SUBJECT: Record of Decision for the Western Groundwater Operable Unit, Aerojet
Superfund Site, Rancho Cordova, California

RECORD OF DECISION
for the
WESTERN GROUNDWATER OPERABLE UNIT
OU-3

**AEROJET SACRAMENTO SITE,
RANCHO CORDOVA, CALIFORNIA**

July 20, 2001

Figure 2-4. Preferred Alternative 4C

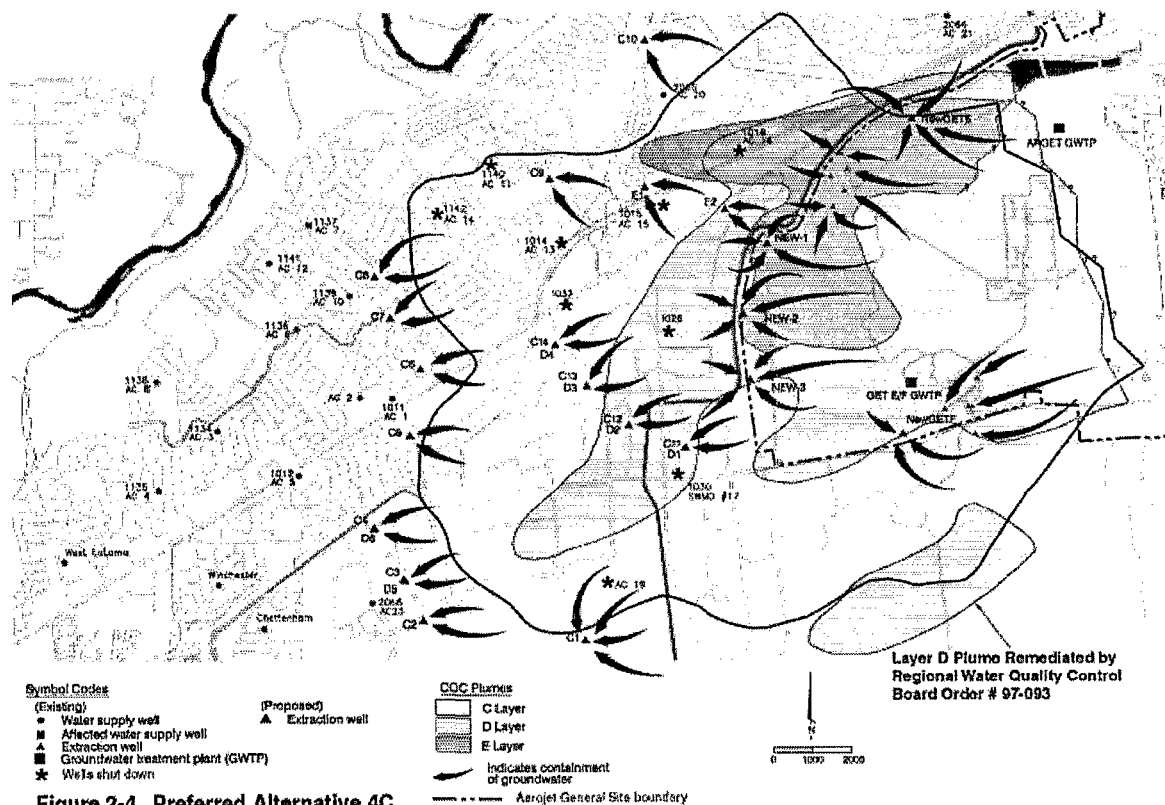
2.14 **Documentation of Significant Changes:** In response to comments from Aerojet received on the National Remedy Review Package, the USEPA added four Layer C (C11, C12, C13 and C14) extraction wells to the Alternative 4C to prevent contamination from migrating from Layer C to D (See Figure 2-4). The cost estimates were increased accordingly. The proposed plan fact sheet inadvertently omitted these wells but they were appropriately shown on story boards shown to the public at the two public meetings.

Aerojet has questioned the ability of the Selected Remedy to prevent contamination migration from the more contaminated Layer C to Layer D for the middle row of extraction wells. The USEPA review has indicated the appropriate remedial design can address the concern. Extraction wells C11 through C14 were added to the cost estimate based on particle tracking modeling to address the concern.

- The third priority is to expedite remediation of the groundwater and prevent further degradation off-property of Layers D and E. An evaluation of *in-situ* bioremediation or a combination of the P&T and *in-situ* bioremediation shall be conducted to allow the EPA to determine whether these components can be effectively and economically implemented to expedite remediation of the groundwater as a possible revision to the remedy. Unless the remedy is revised, the groundwater remediation shall be expedited through interior P&T wells (Figure 2-4 wells E2, C11 through C14 and D1 through D4).
